TANNER RANCH FILING NO. 1

SITE CONSTRUCTION DRAWINGS

EL PASO COUNTY, COLORADO

Tanner Ranch Fil #2

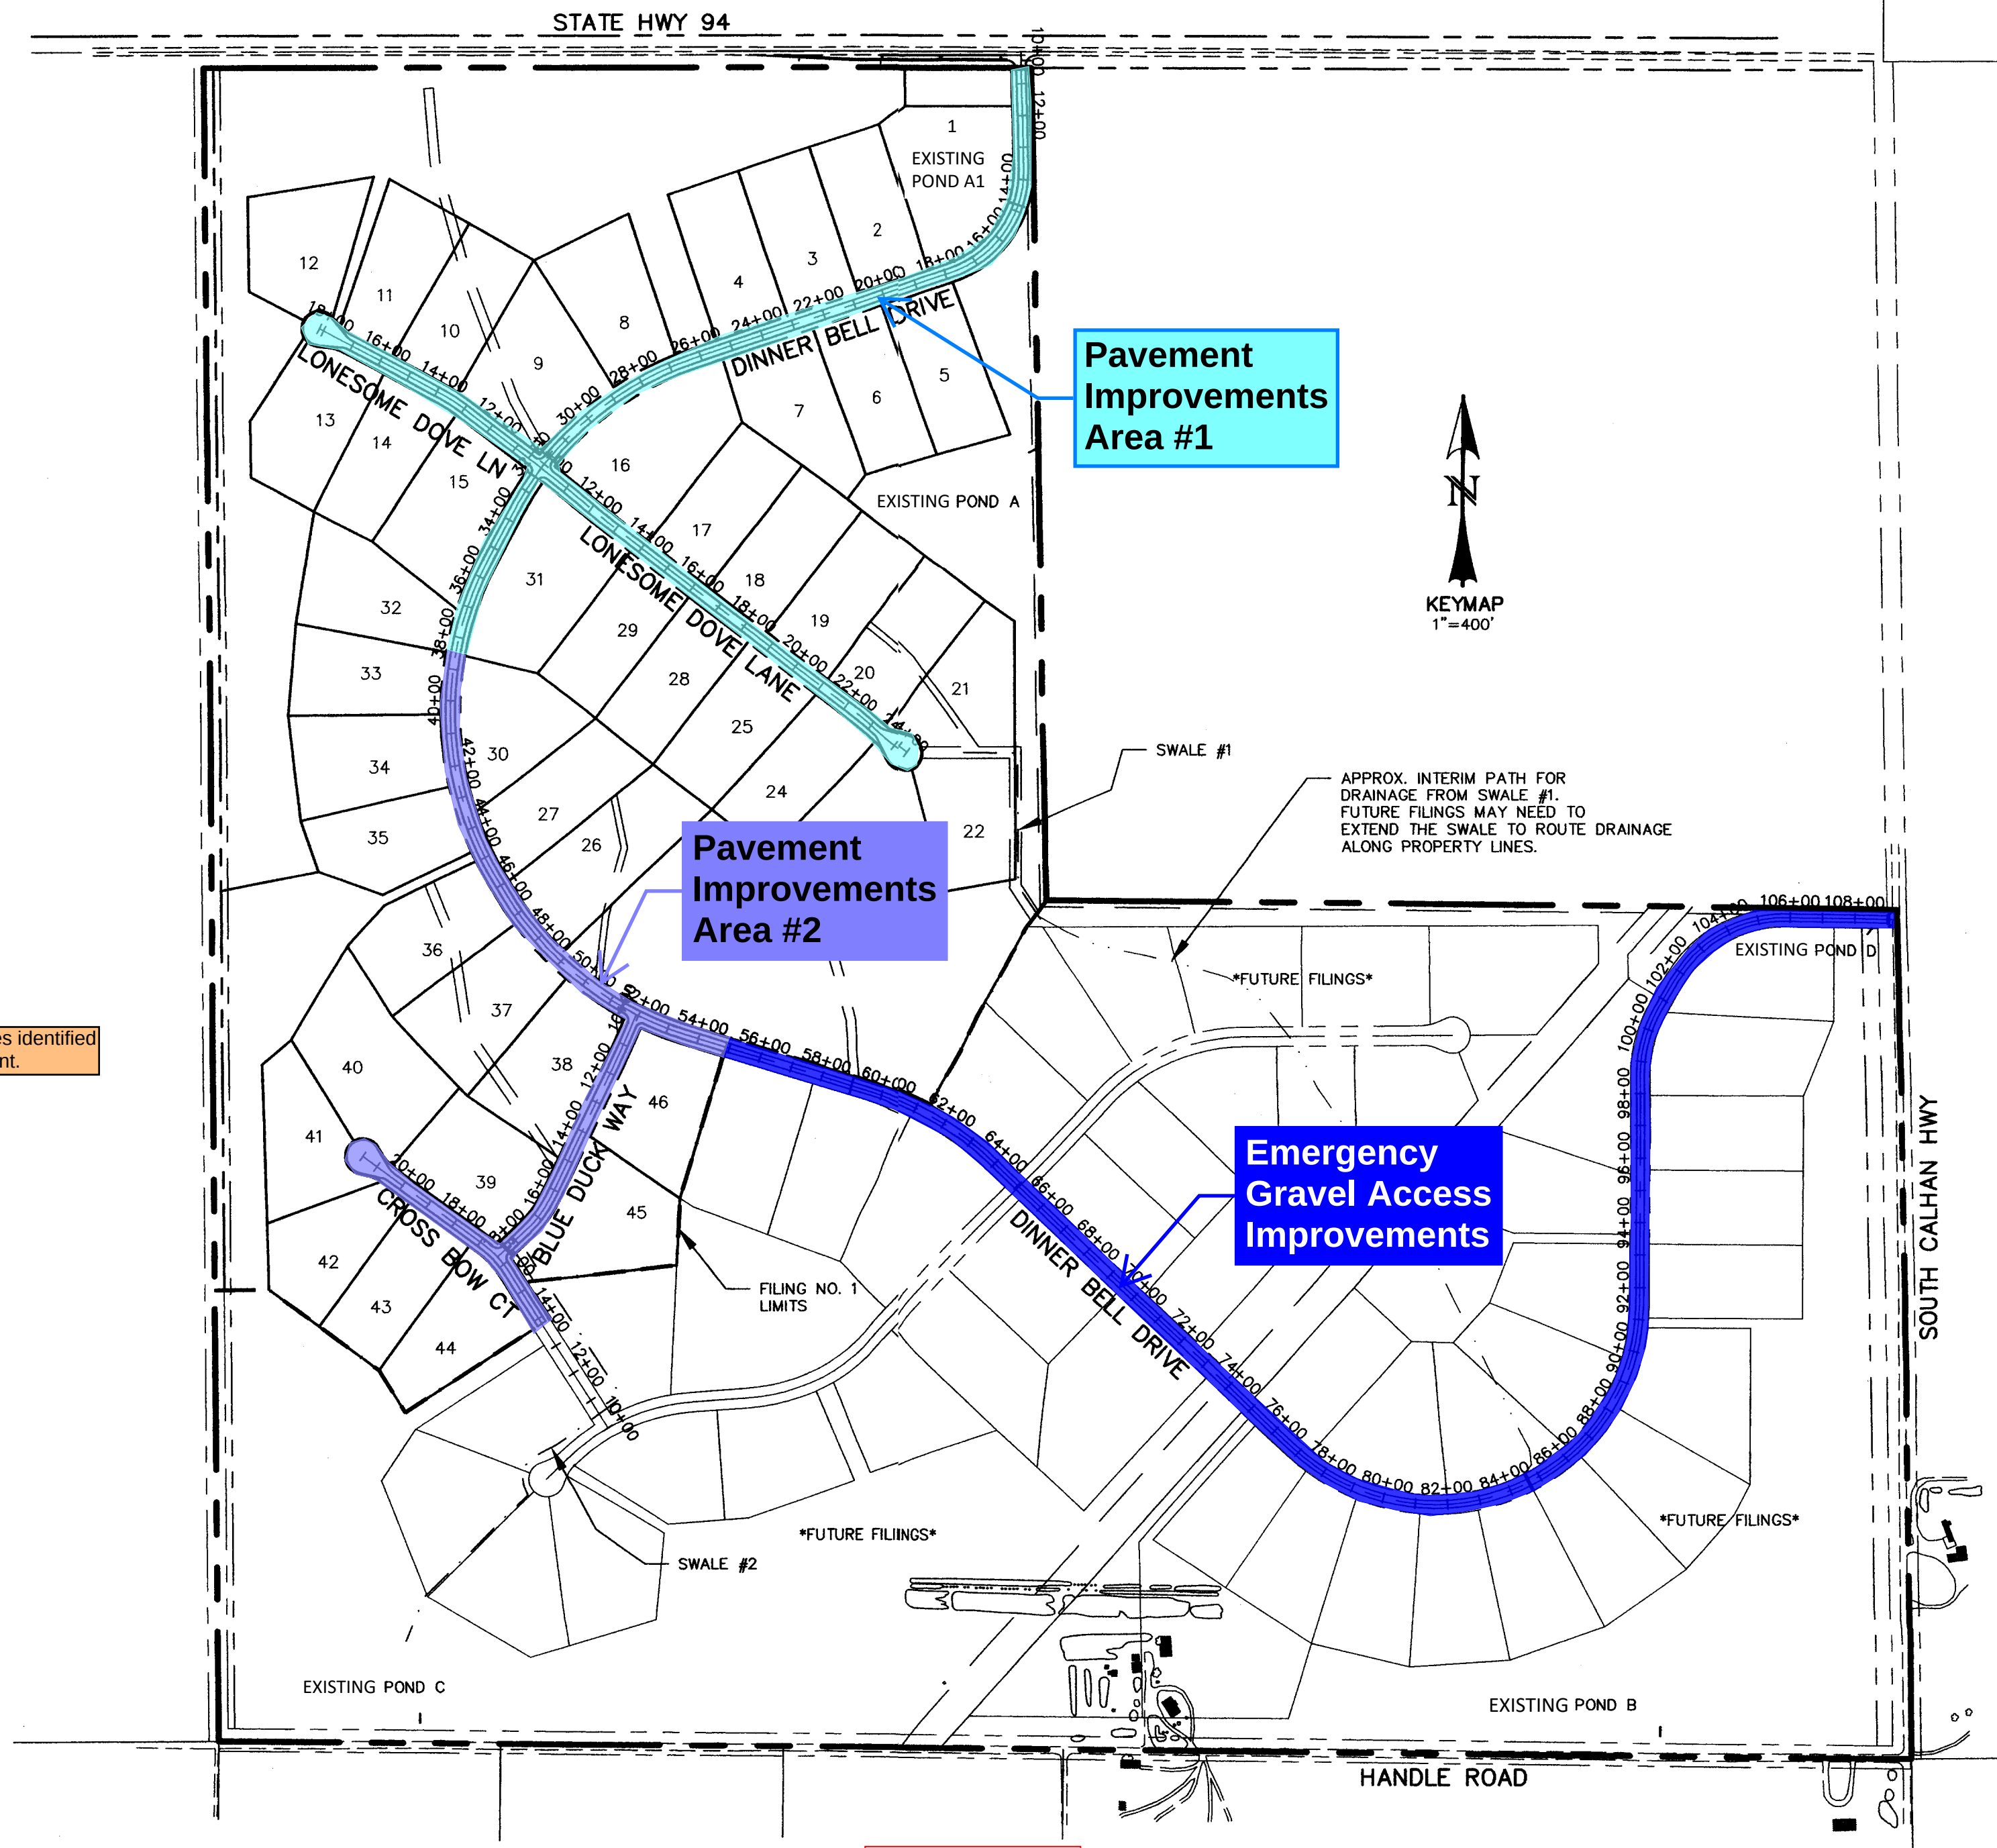
Add stamp for all sheets with changes identified as "2026 Revisions" - typical comment.
